Supplementary Statement

**Proposed Temporary Public Vehicle Park (excluding Container Vehicle) for a Period of 5 Years
in “Village Type Development” Zones, Various Lots in D.D. 128 and D.D. 129,
Lau Fau San, Yuen Long, New Territories**

Appendix I – Response-to-Comment Table

Title:		D01	
Drainage Proposal			
Drawn by:	DM	Date:	15-3-2024
Check by:	DM	Scale:	----

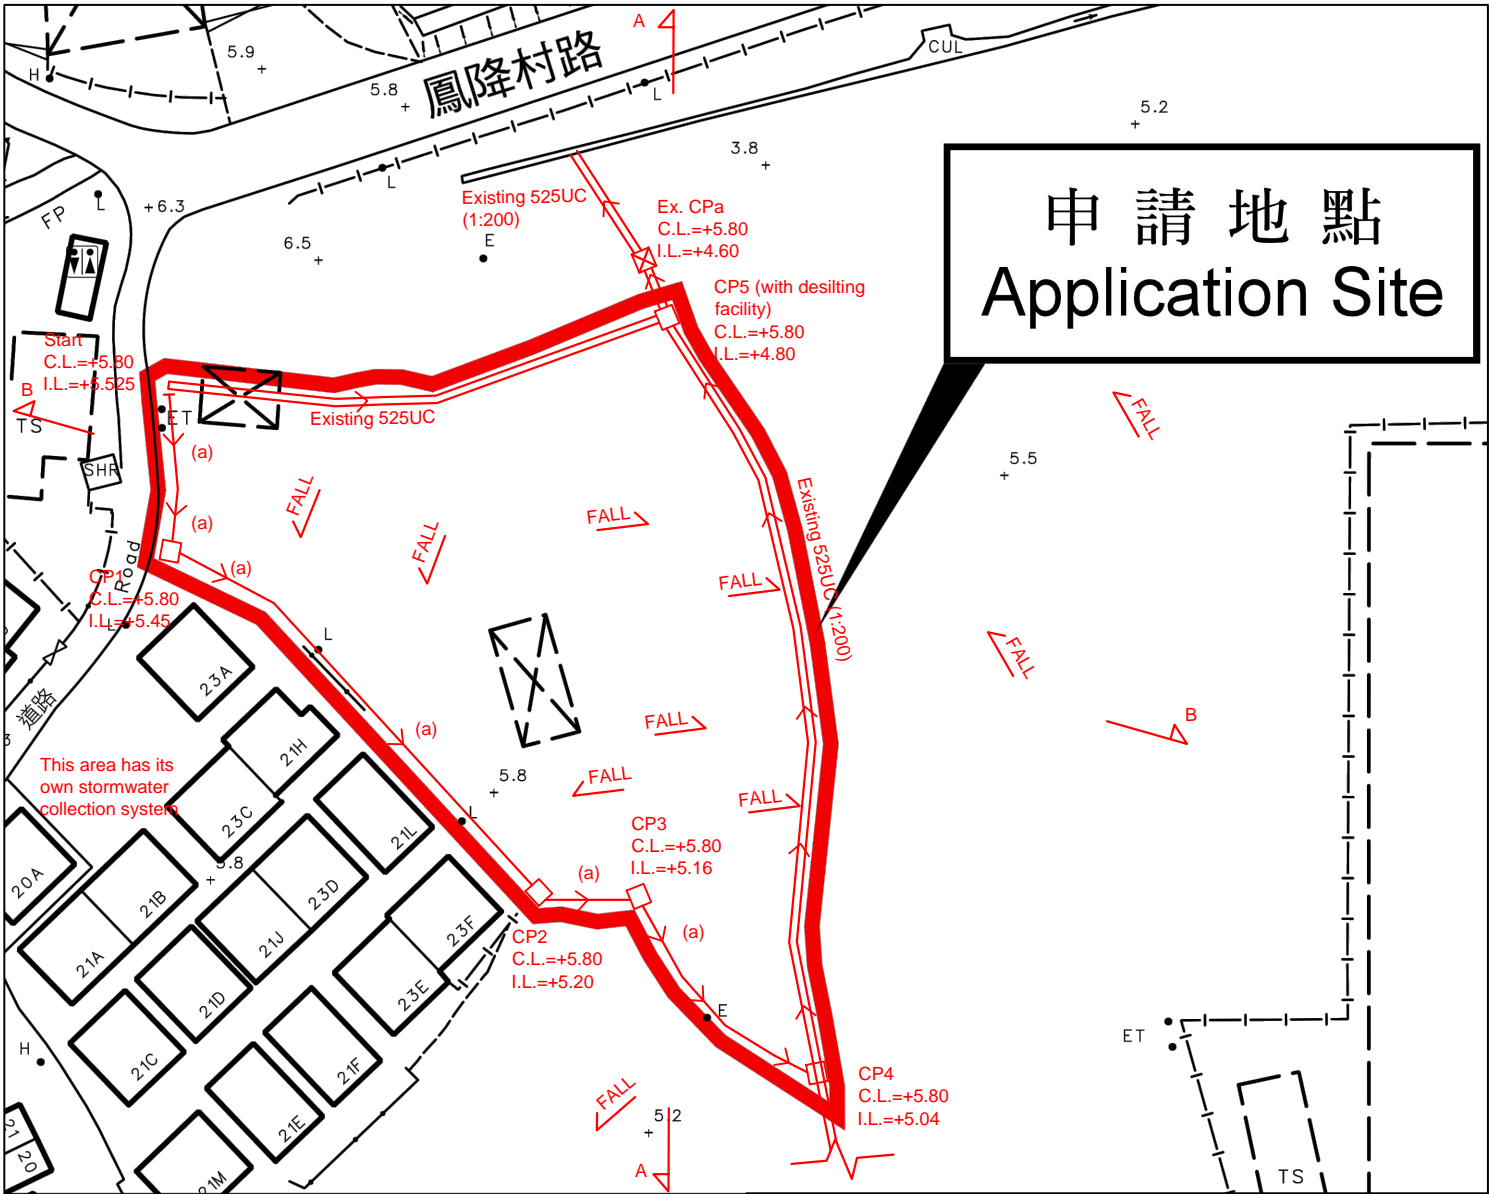
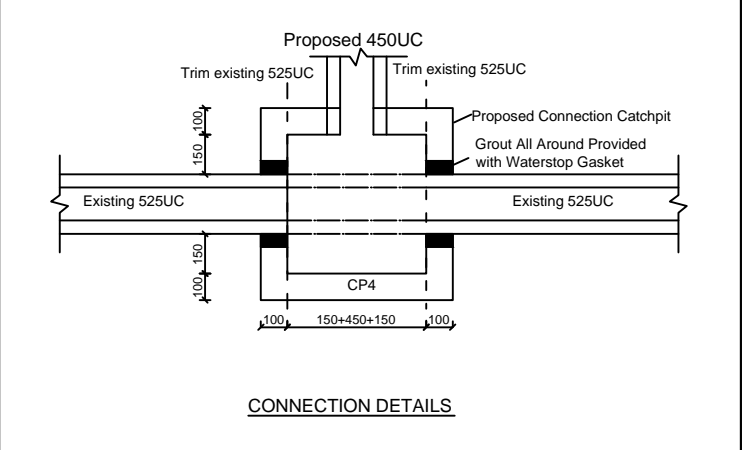
(i)	Please demonstrate with hydraulic calculation that the existing 525UC are adequate to collect, convey and discharge the surface runoff accrued on the application site and the overland flow intercepted from the adjacent lands.	Noted. Please be confirmed that the hydraulic calculation for existing 525UC is provided.
(ii)	The existing channel, to which the applicant proposed to discharge the stormwater from the subject site was not maintained by this office. The applicant should identify the owner of the existing drainage facilities and shall demonstrate that the drainage facilities can be practicably implemented and maintained. In the case that it is a local village drains, DO/YL should be consulted.	Noted.

CRITICAL CATCHMENT AREA (refer to D02)
CATCHMENT AREA = 1693SQ.M
Q = 0.278CiA
= 0.278 * 0.95 * 250 * 1693 / 1000000
= 0.112 M3/S
= 6707 lit/min
PROVIDE 450HRUC (1:200) IS OK (FIG. 8.7)
